## VARIANCE REQUEST

Iowa Department of Natural Resources

1. Date	: 9/24/91	13. Decision:	Approved
2. Review Engineer	: Fred Evans	Date:	9/25/91
3. Date Received	: 8/12/91 & 9/4/91	14. Appeal:	
4. Facility Name	: City of Leon	Date:	
5. County Number	: 27		
6. Program Area	: CP		
7. Facility Type	: CO1		
8. Subject Area	: 305		
9. Rule Reference	: 64.2(9)		
10. Design Std. Ref.	: 12.5.1		
11. Consulting Engr.	: Howard R. Green		
12. Variance Rule	: 64.2(9)C

## 15. Description of Variance Request

Proposed 6" Sanitary  
Main Extension  
LEON, IA.

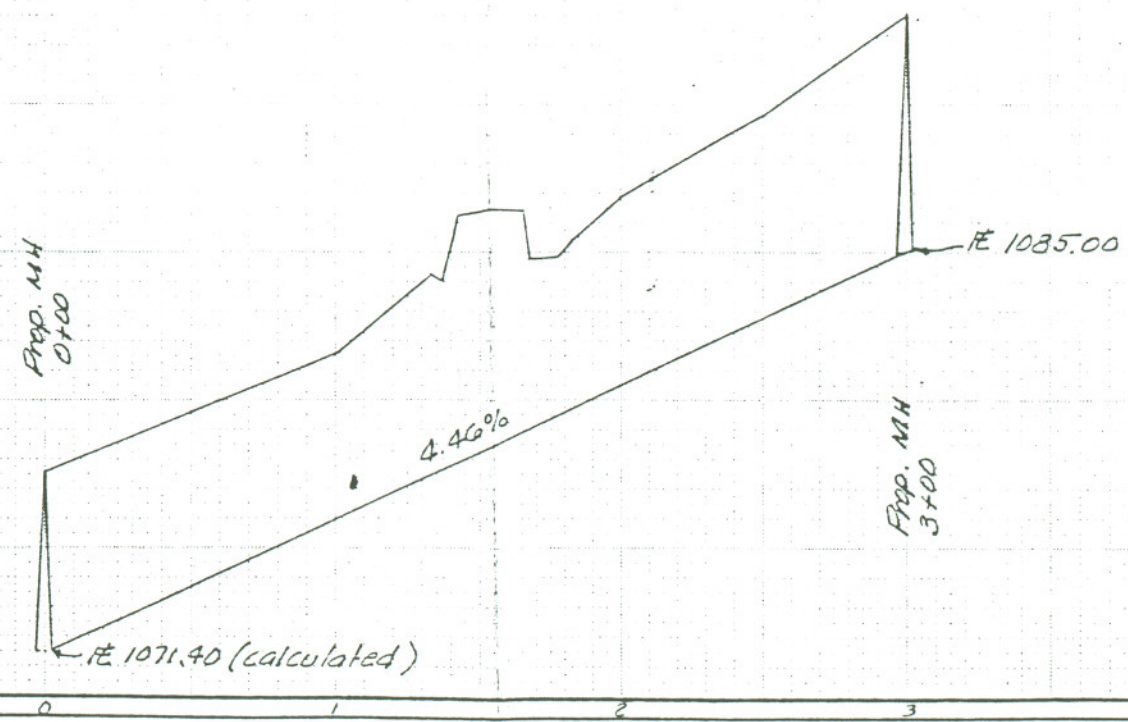
Prop. manhole 0+00  
to be constructed  
over exist. 6" sewer  
main.

Prop. 300' of 6" SDR 35  
sanitary sewer main

Prop. manhole 3+00
